| MARK | DATE | DESCRIPTIONS | BY | CH'D | CCO# |
|---|---|---|---|---|---|
| 0 | 03/08/10 | MEP INTEGRATION | JE | SYC | 110 |

CONTRACT CHANGE ORDER NO._____
SHEET _____ OF _____

# DETAILS
## SCADA REMOTE TERMINAL UNIT SYSTEM TELEPHONE CABLE BLOCK DIAGRAM WESTBOUND
NO SCALE

**E-962**

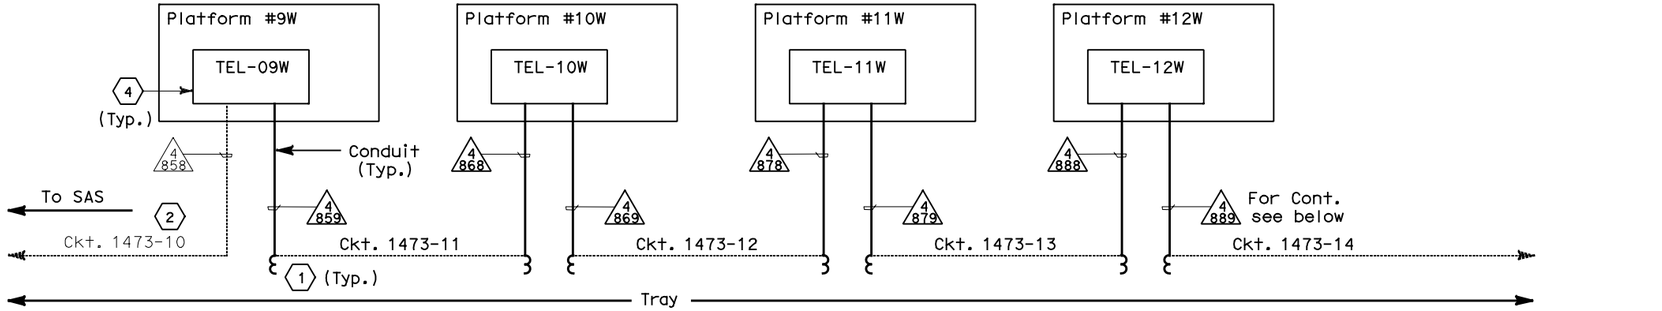
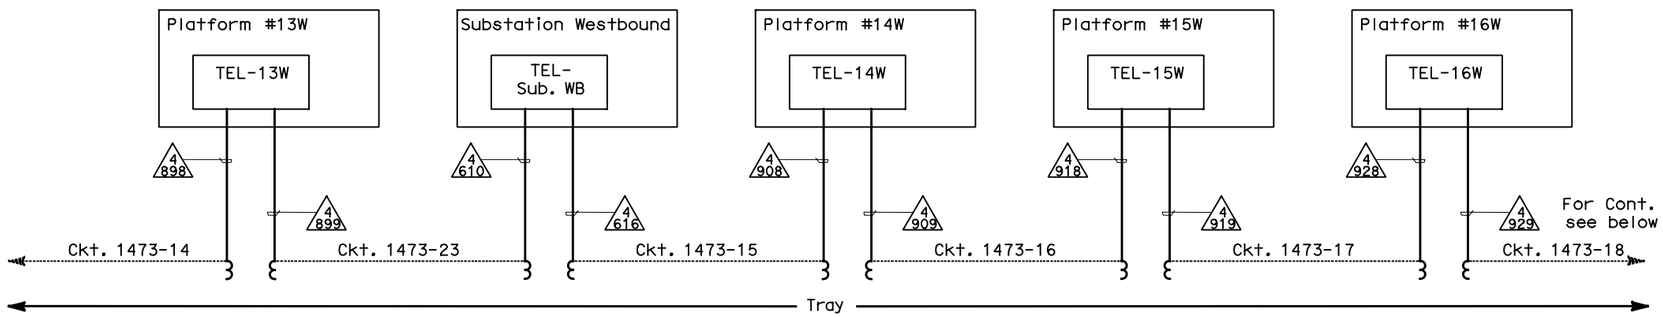
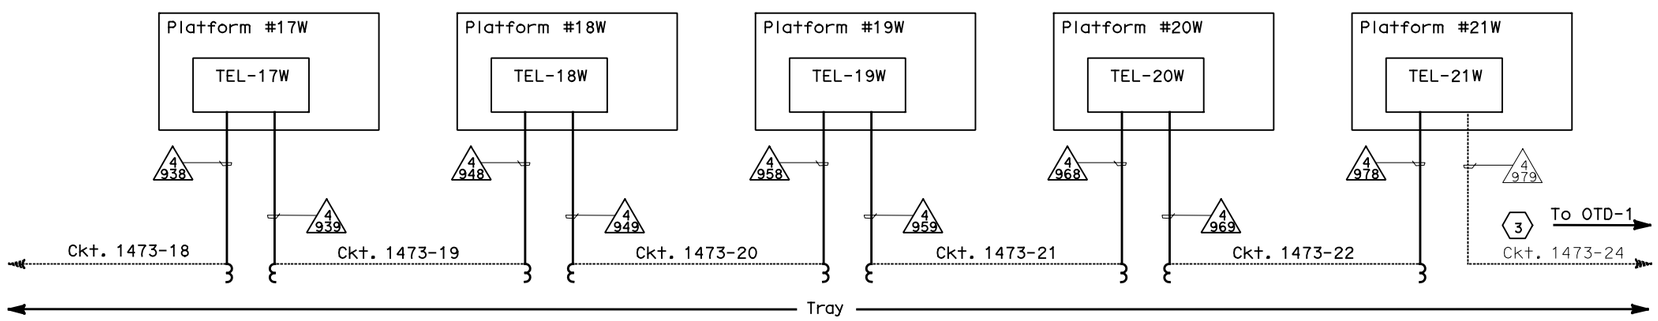
1. All circuits (50 pair #18) shown on this drawing have been installed in the TOS/COM trays spanning the entire Skyway. At each platform the circuits have been coiled in the trays. Contractor shall pull the 50 pair #18 Telephone Cables from the trays into the Telephone Terminal Boxes as follows:

At platform 09W: Pull ckt #1473-10 in conduit # 4858 to TEL-09W.
   At platform 09W: Pull ckt #1473-11 in conduit # 4859 to TEL-09W.
   At platform 10W: Pull ckt #1473-11 in conduit # 4868 to TEL-10W.
   At platform 10W: Pull ckt #1473-12 in conduit # 4869 to TEL-10W.
   At platform 11W: Pull ckt #1473-12 in conduit # 4878 to TEL-11W.
   At platform 11W: Pull ckt #1473-13 in conduit # 4879 to TEL-11W.
   At platform 12W: Pull ckt #1473-13 in conduit # 4888 to TEL-12W.
   At platform 12W: Pull ckt #1473-14 in conduit # 4889 to TEL-12W.
   At platform 13W: Pull ckt #1473-14 in conduit # 4898 to TEL-13W.
   At platform 13W: Pull ckt #1473-23 in conduit # 4899 to TEL-13W.
   At Substation W: Pull ckt #1473-23 in conduit # 4610 to TEL-Sub. WB.
   At Substation W: Pull ckt #1473-15 in conduit # 4616 to TEL-Sub. WB.
   At platform 14W: Pull ckt #1473-15 in conduit # 4908 to TEL-14W.
   At platform 14W: Pull ckt #1473-16 in conduit # 4909 to TEL-14W.

At platform 15W: Pull ckt #1473-16 in conduit # 4918 to TEL-15W.
   At platform 15W: Pull ckt #1473-17 in conduit # 4919 to TEL-15W.
   At platform 16W: Pull ckt #1473-17 in conduit # 4928 to TEL-16W.
   At platform 16W: Pull ckt #1473-18 in conduit # 4929 to TEL-16W.
   At platform 17W: Pull ckt #1473-18 in conduit # 4938 to TEL-17W.
   At platform 17W: Pull ckt #1473-19 in conduit # 4939 to TEL-17W.
   At platform 18W: Pull ckt #1473-19 in conduit # 4948 to TEL-18W.
   At platform 18W: Pull ckt #1473-20 in conduit # 4949 to TEL-18W.
   At platform 19W: Pull ckt #1473-20 in conduit # 4958 to TEL-19W.
   At platform 19W: Pull ckt #1473-21 in conduit # 4959 to TEL-19W.
   At platform 20W: Pull ckt #1473-21 in conduit # 4969 to TEL-20W.
   At platform 20W: Pull ckt #1473-22 in conduit # 4968 to TEL-20W.
   At platform 21W: Pull ckt #1473-22 in conduit # 4978 to TEL-21W.
   At platform 21W: Pull ckt #1473-24 in conduit # 4979 to TEL-21W.

(1) All 50 pair #18 telephone cables are coiled in the trays in the girder at the platform locations.

(2) The SAS Contractor is responsible for pulling and terminating Ckt #1473-10.

(3) The OTD-1 Contractor is responsible for pulling and terminating Ckt #1473-24.

(4) Contractor shall terminate all 50 pair #18 cables in the Telephone Terminal Boxes, unless otherwise noted.
